Job:
RESIDENTIAL FLAT
BUILDING: - 1147, 1149
PACIFIC HWY & 2 BOBBIN
HEAD ROAD PYMBLE

BASEMENT LEVEL 1

SK04A

FSR COMPLIANCE DIAGRAM - THIRD FLOOR PLAN
SCALE 1:100 @ A0

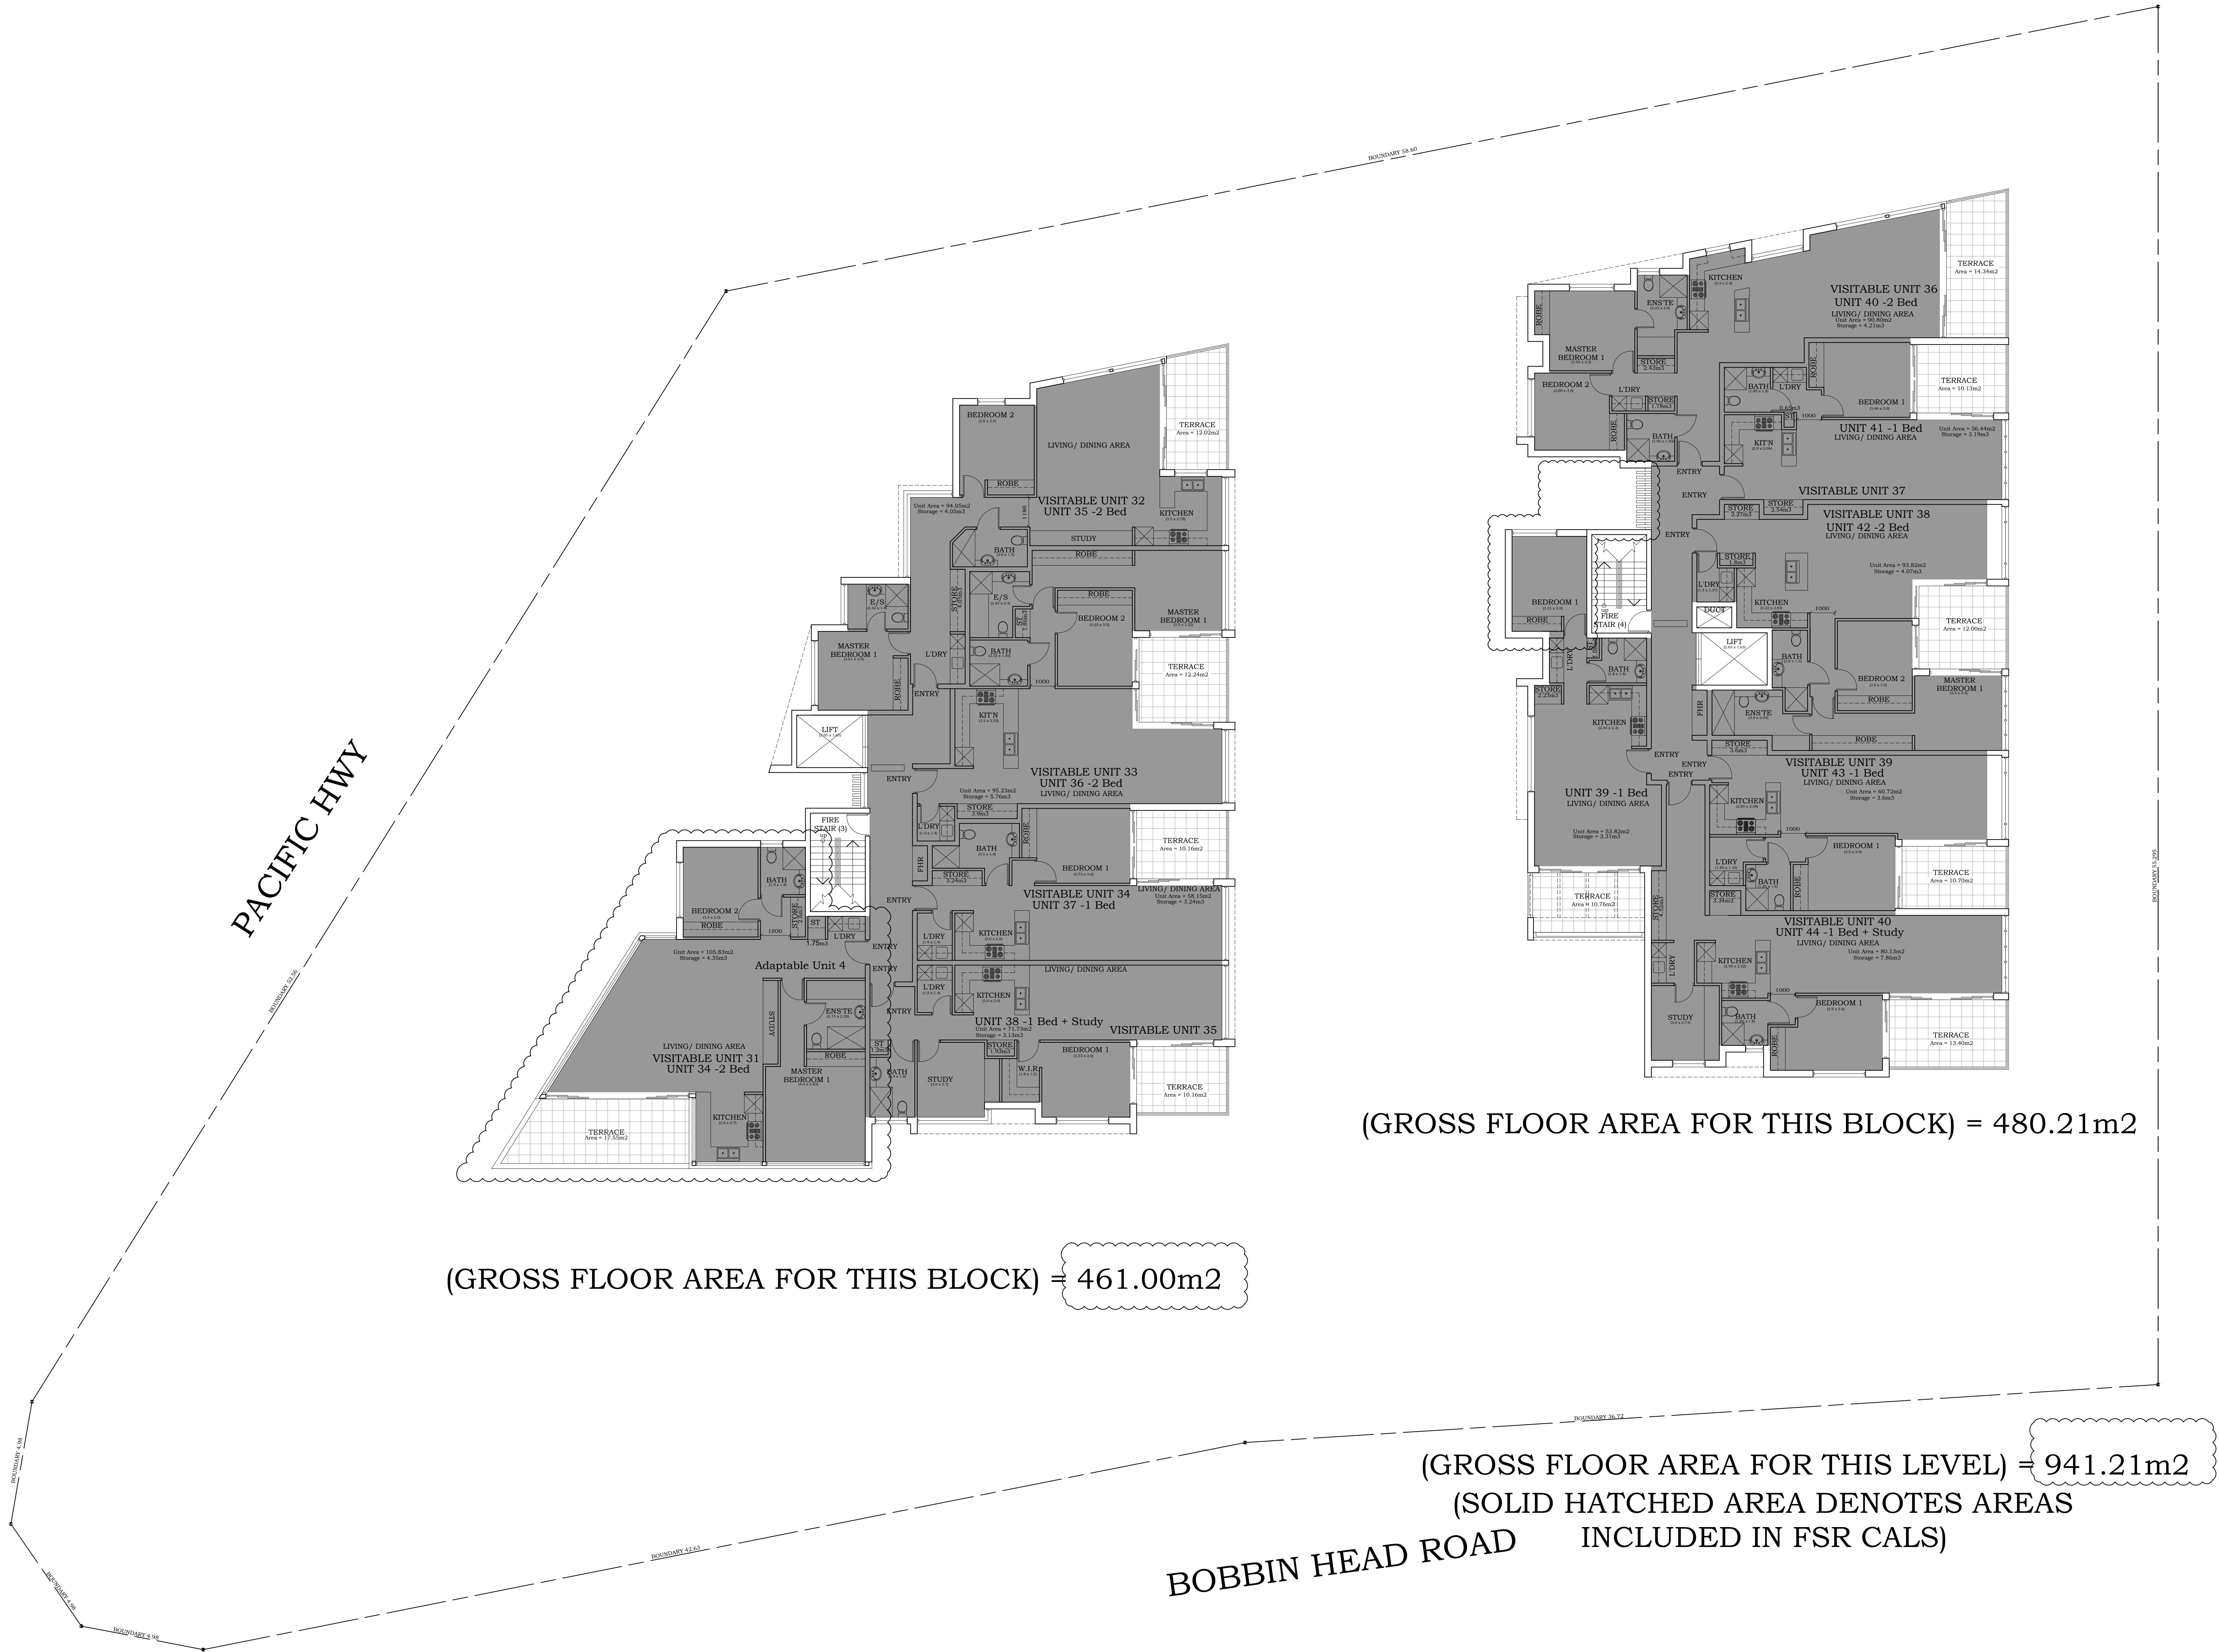
REV	AMENDMENTS	DATE
A	- layout of Unit 34 has been amended so that the building form addresses the corner.	30.05.11

SOLAR COMPLIANCE DIAGRAM - FIRST FLOOR PLAN
SCALE 1:100 @ A0

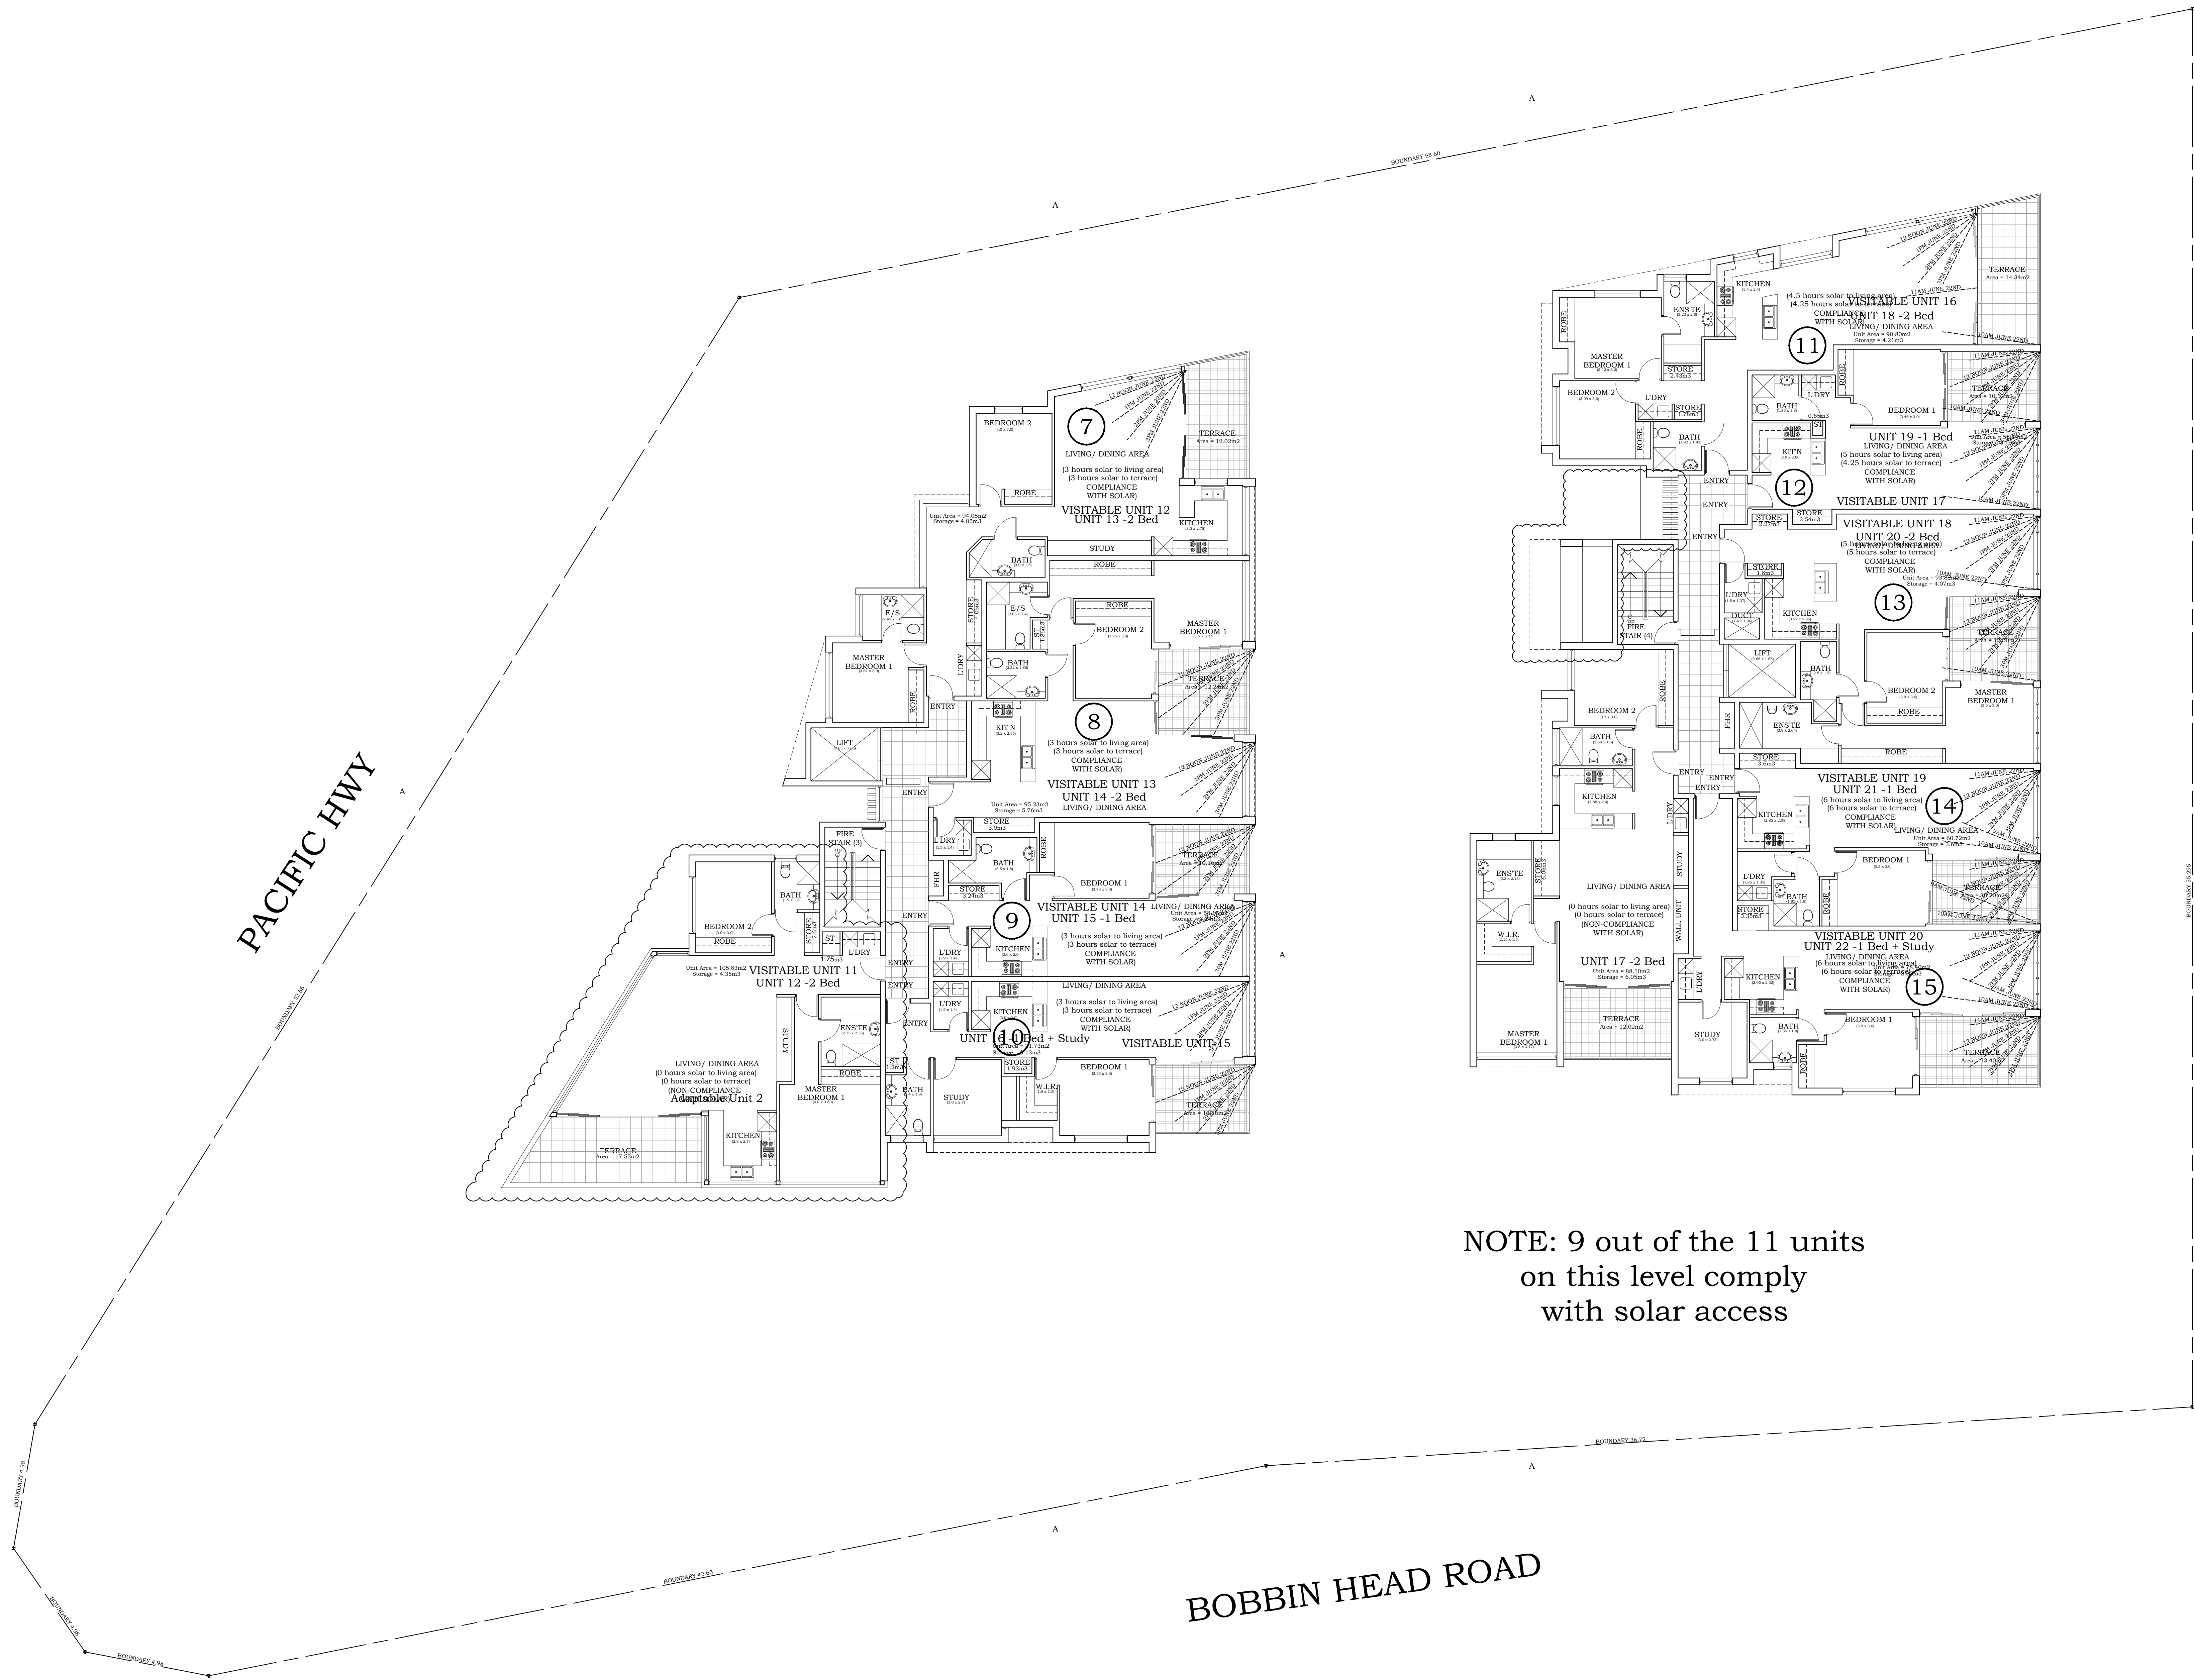
REV	AMENDMENTS	DATE
A	- layout of Unit 12 has been amended so that the building form addresses the corner.	30.05.11

SOLAR COMPLIANCE DIAGRAM - THIRD FLOOR PLAN
SCALE 1:100 @ A0

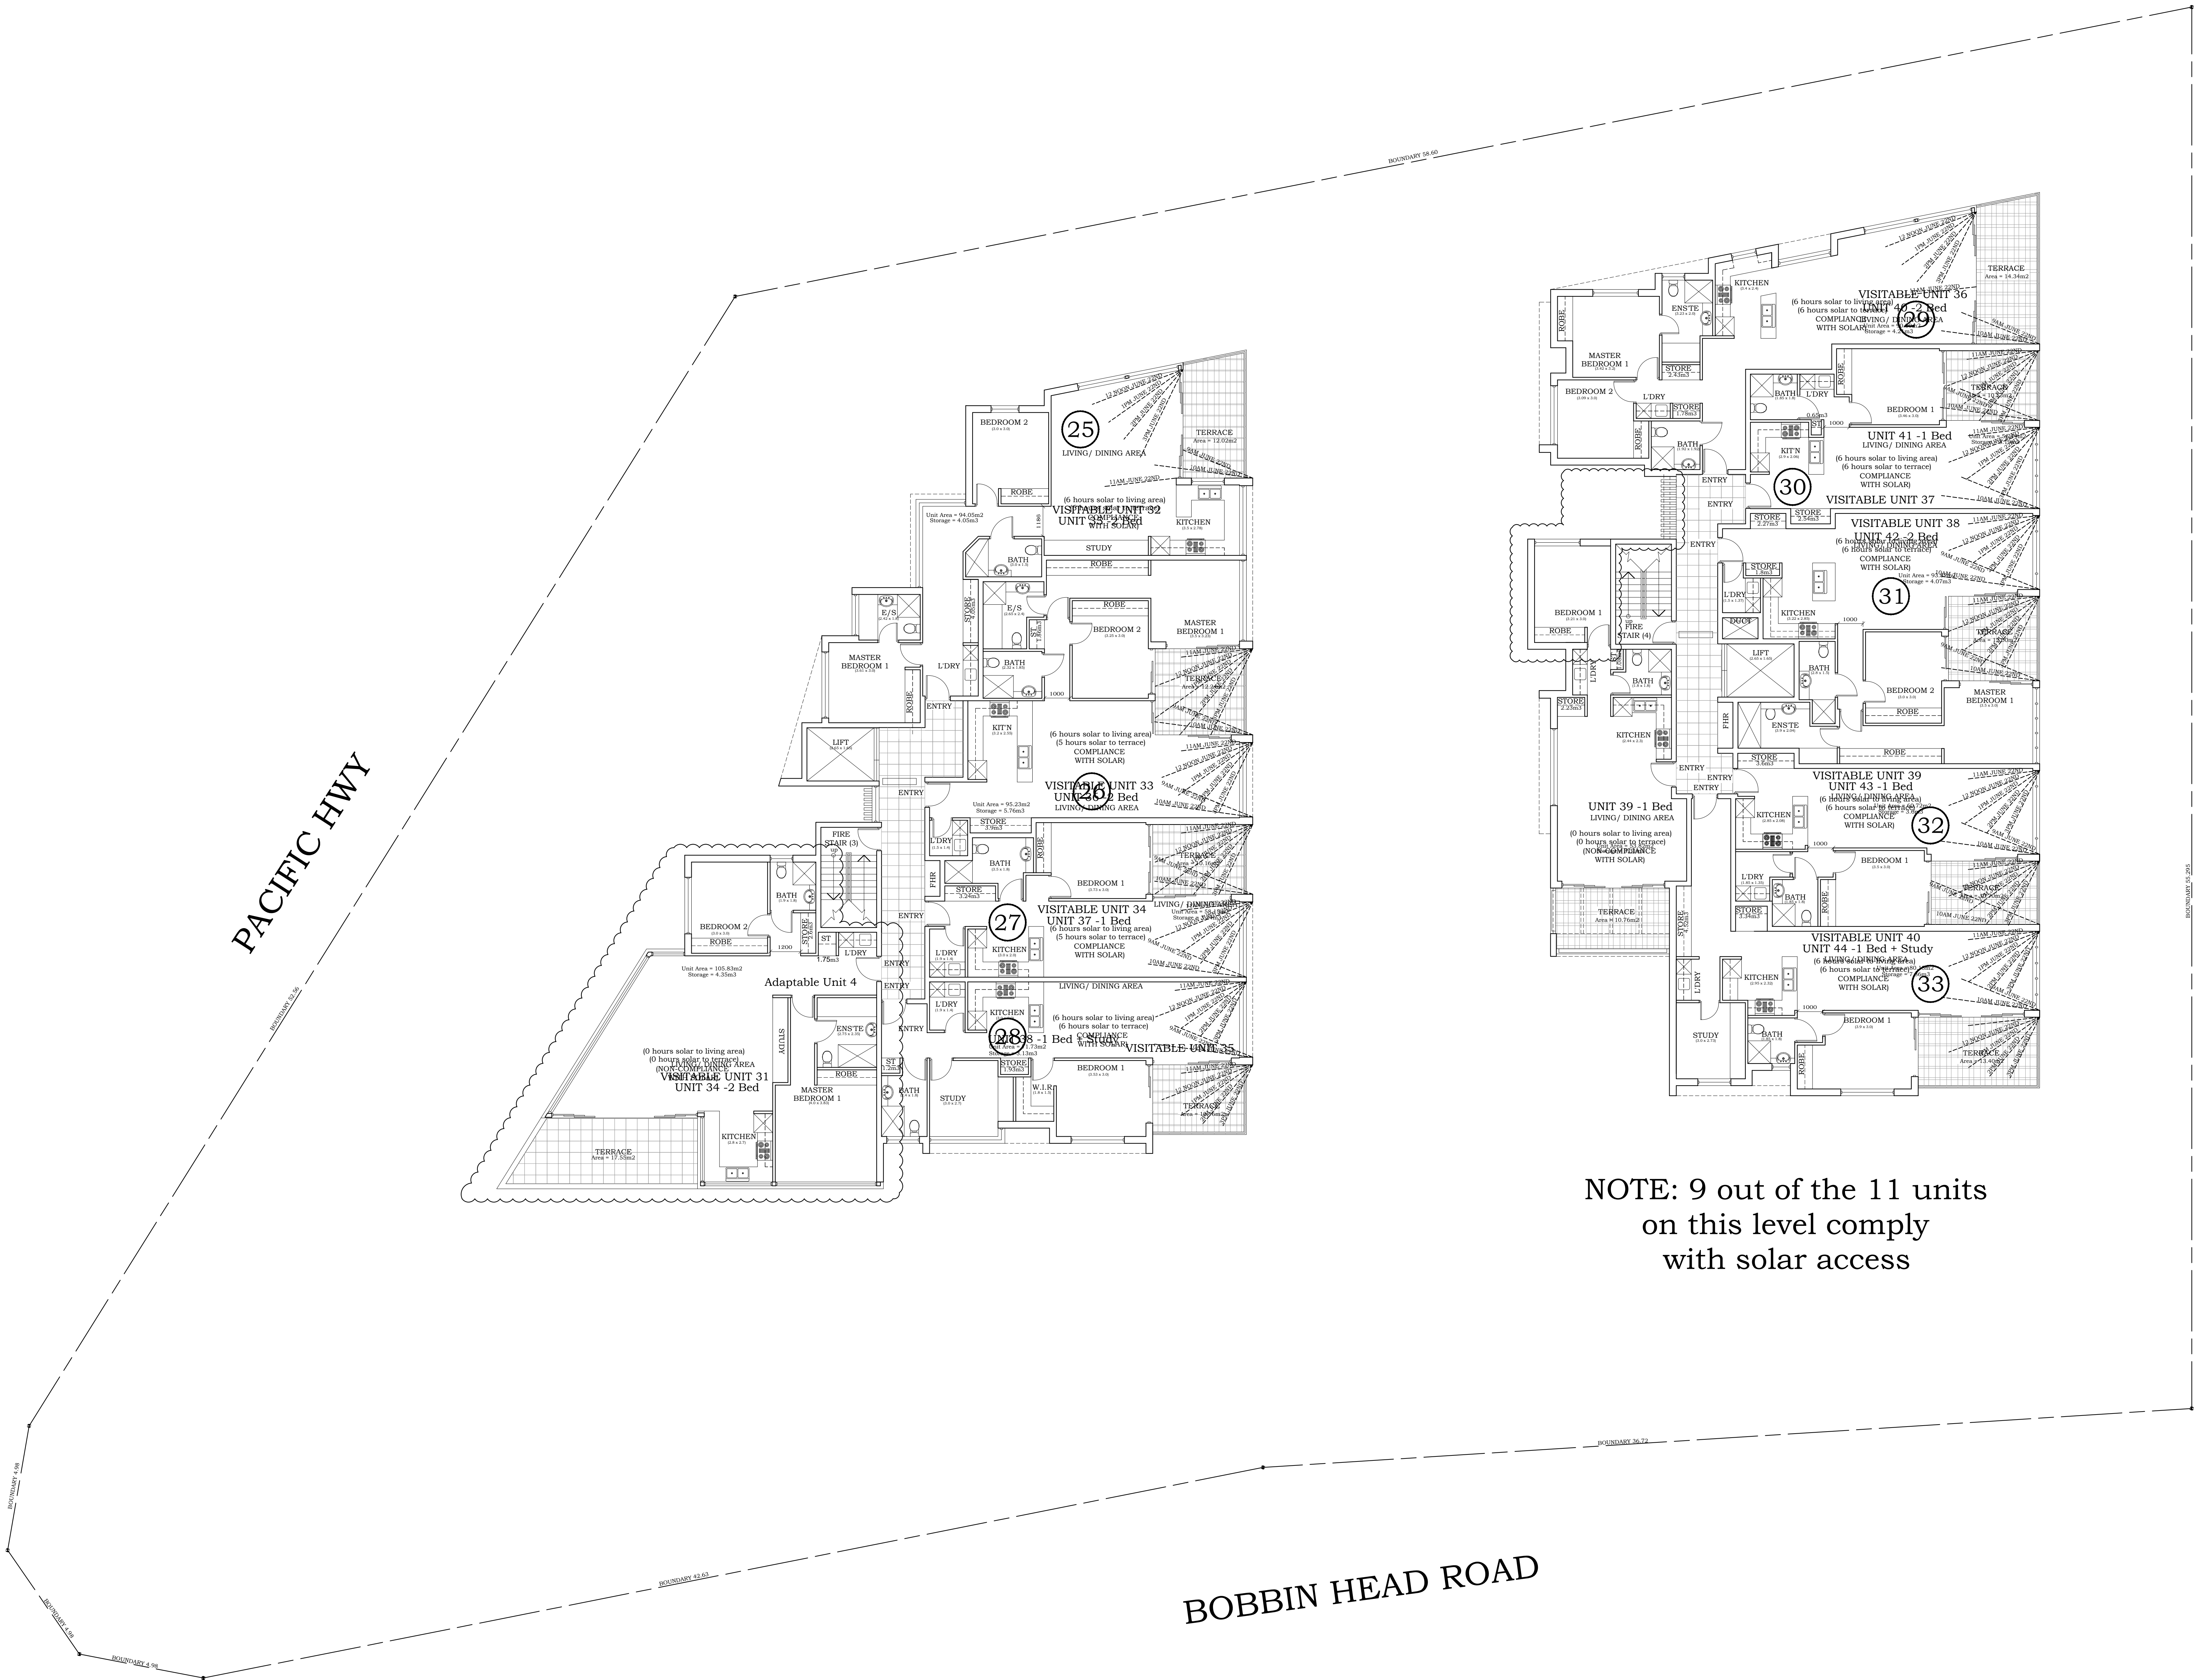
REV	AMENDMENTS	DATE
A	- layout of Unit 34 has been amended so that the building form addresses the corner.	30.05.11
